(ITB NO. 5603)
EIGHT (8) CLASSROOM ADDITION TO
INDIAN TRAIL MIDDLE SCHOOL
307 CAR-MOL DRIVE
JOHNSON CITY, TENNESSEE

BEESON, LUSK & STREET, INC., ARCHITECTS
207 EAST MAIN STREET, SUITE 3C
P.O. BOX 1909 ZIP CODE 37605-1909
JOHNSON CITY, TN 37604-5749
PHONE: 423-928-1175 EMAIL: bls@blsarch.com

SEPTEMBER 13, 2012

ADDENDUM NO. 2

5. Refer to Drawing SW-2:

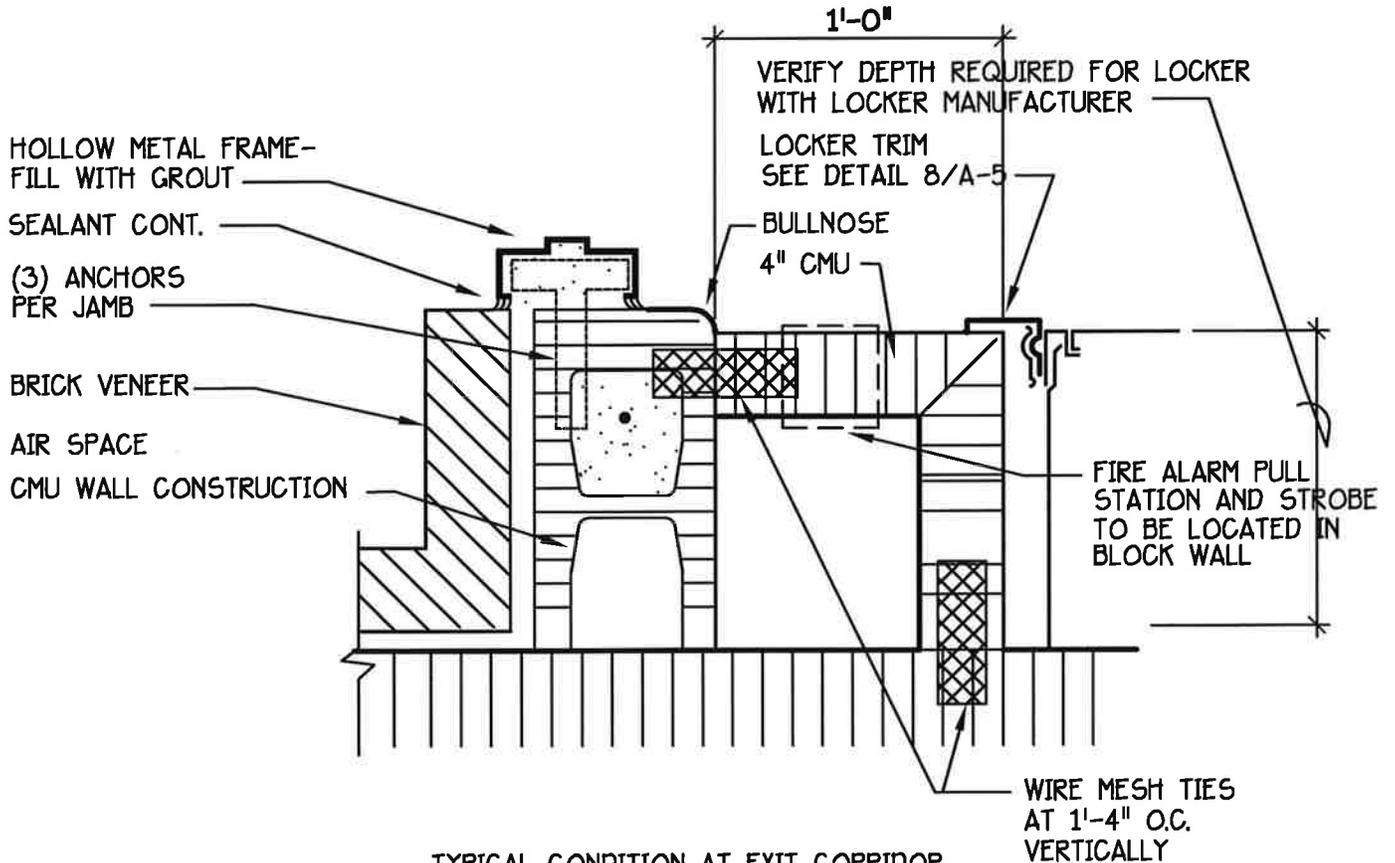
- A. Existing concrete sidewalk extending between Classroom Addition 'A' and 'B' to be Note 13 in lieu of Note 12 shown. Sidewalk may remain if not damaged by construction.
- B. Concrete sidewalks, outside of construction fencing, are to be replaced/installed only if damaged by construction.
- C. Contractor to fence around fire hydrant on south side of construction in lieu of gate shown (Note No. 6). Provide minimum 3'-0" clearance to hydrant.
- D. Contractor to provide Type 'A' standard silt fence along north construction fencing.

1
AD2-1 **JAMB DETAIL**
 SCALE: 1 1/2"=1'-0"

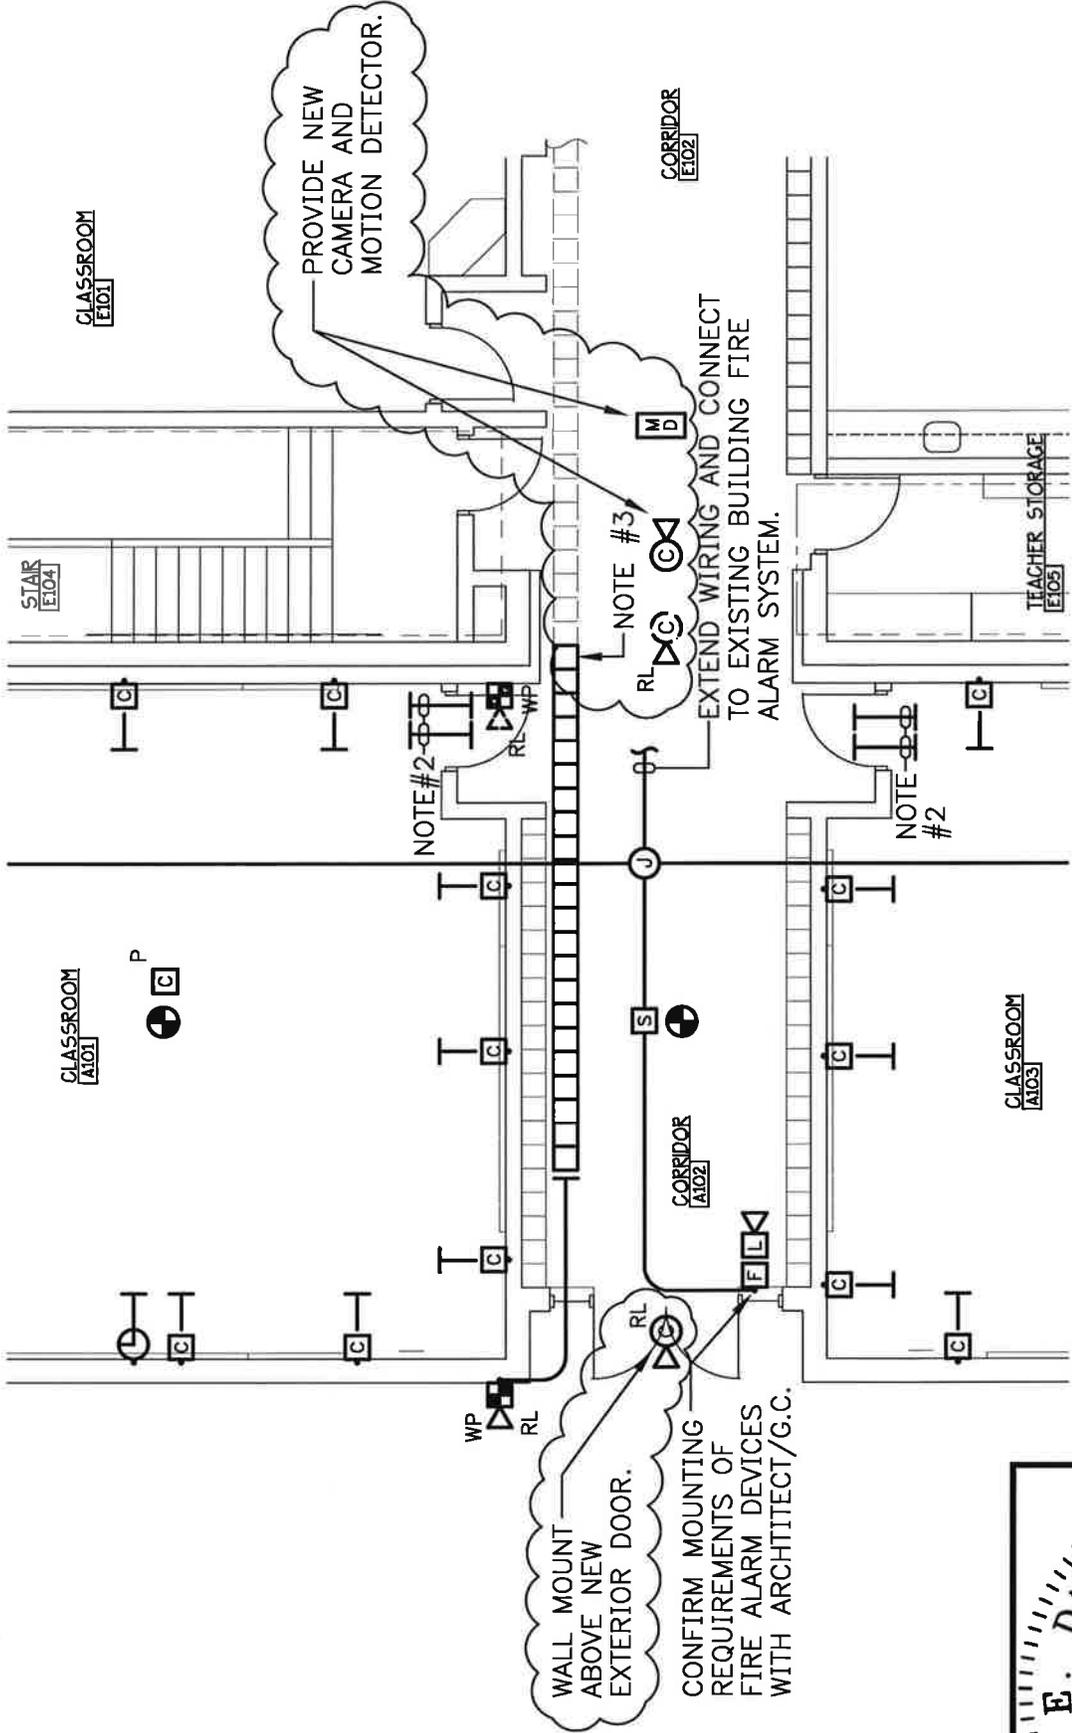
TYPICAL CONDITION AT EXIT CORRIDOR
 FOR PLACEMENT OF FIRE ALARM PULL
 STATION AND STROBE - 1ST FLOOR OF ADDITION 'A' AND 'B'
